APPLICATION FOR AMENDMENT TO
OPERATING LICENSE

Description of Proposed Changes

Indian Point Unit No. 2
Docket No. 50-247

Facility Operating License No. DPR-26
January 6, 1976

Figure 6.2-1 Facility Management and Technical Support Organization

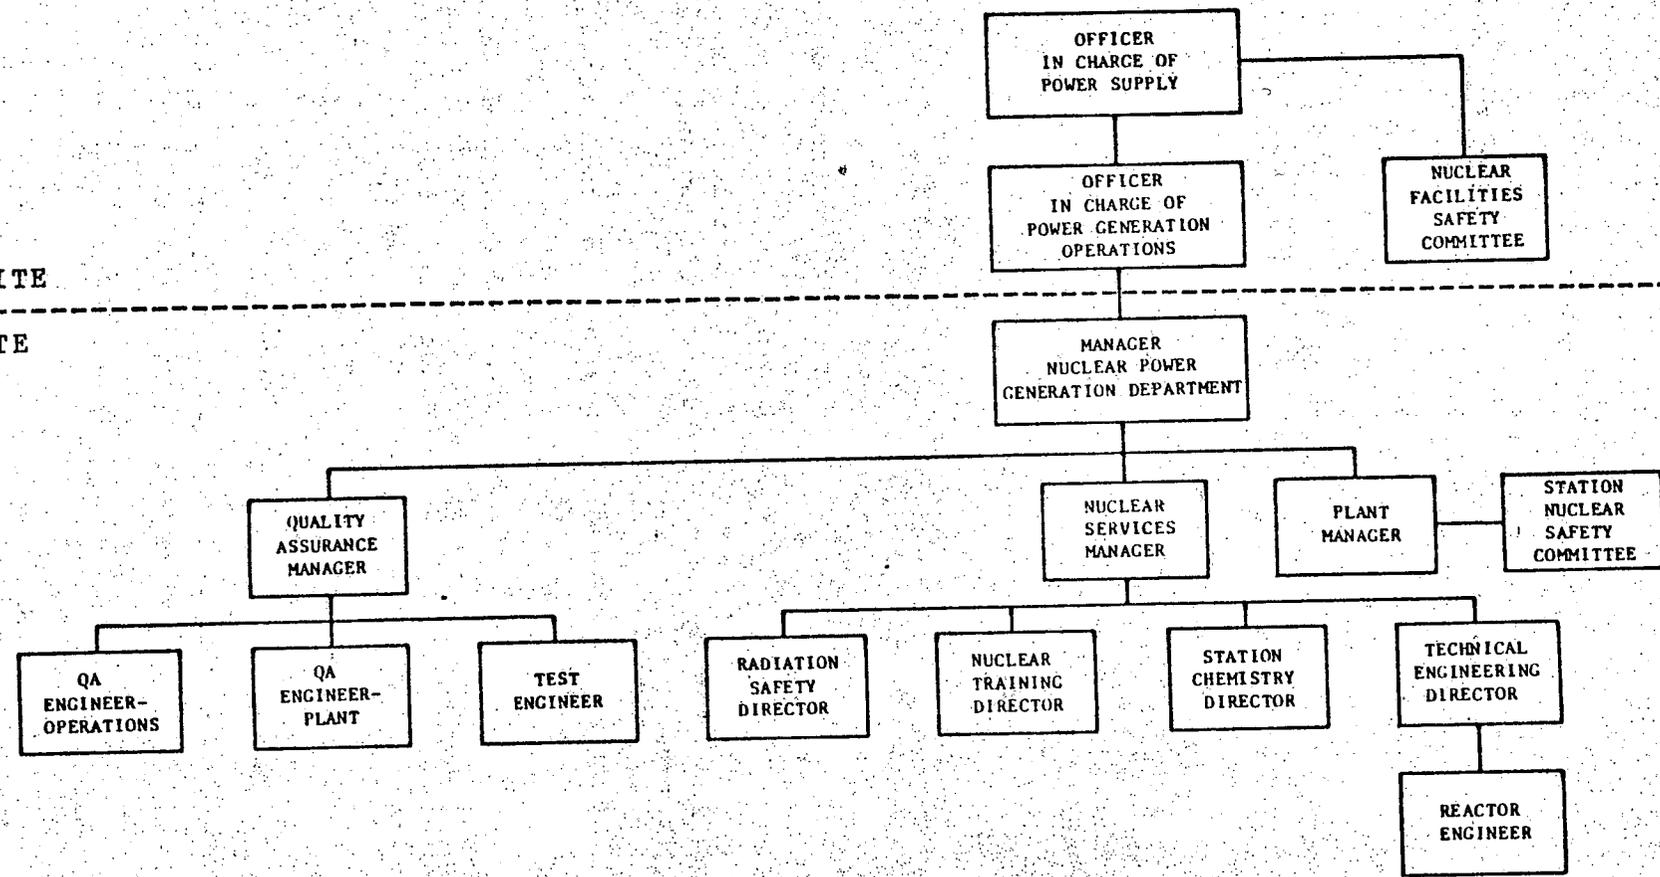
| <u>Page</u> | <u>Item</u> | <u>Existing Specification</u> | <u>Proposed Specification</u> | <u>Explanation of Change</u> |
|-------------|---------------|--|--|---|
| 6-2 | Figure 6.2-1 | Organizational Chart for Facility Management and Technical Support Organization. | Same chart but includes line separating onsite positions from offsite positions. | Editorial change to render the IP2 Technical Specifications consistent with the IP3 Technical Specifications. |
